# TECH edition

Topic : **ES273-2.**  
 TEC edition No : TEC/E/002/2015  
 Date issued : 19/3/2015  
 DESCRIPTION : **Replace SWS-2510 with SWS-E35F-10**

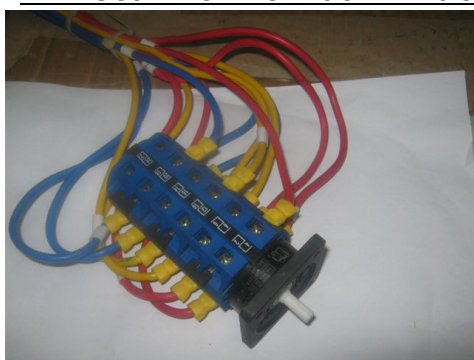
**PREVIOUSLY : SWITCH:10 STEP 220-308V 25A**

**PART NO: SWS-2510**

<u>STEP SWITCH</u>	<u>WIRING NO</u>
1	1
3	3
5	5
7	7
9	9
11	11
13	13
15	15
17	17
19	19
21	21
23	23
4	4
12	12
20	20

**REPLACE: 10-STEPS SWITCH**

**NEW PART NO: SWS-E35F-10**

<u>STEP SWITCH</u>	<u>WIRING NO</u>
23	20
11	12
7	4
24	23
21	21
12	11
13	13
8	7
5	5
1	1
4	3
9	9
15	15
17	17
20	19
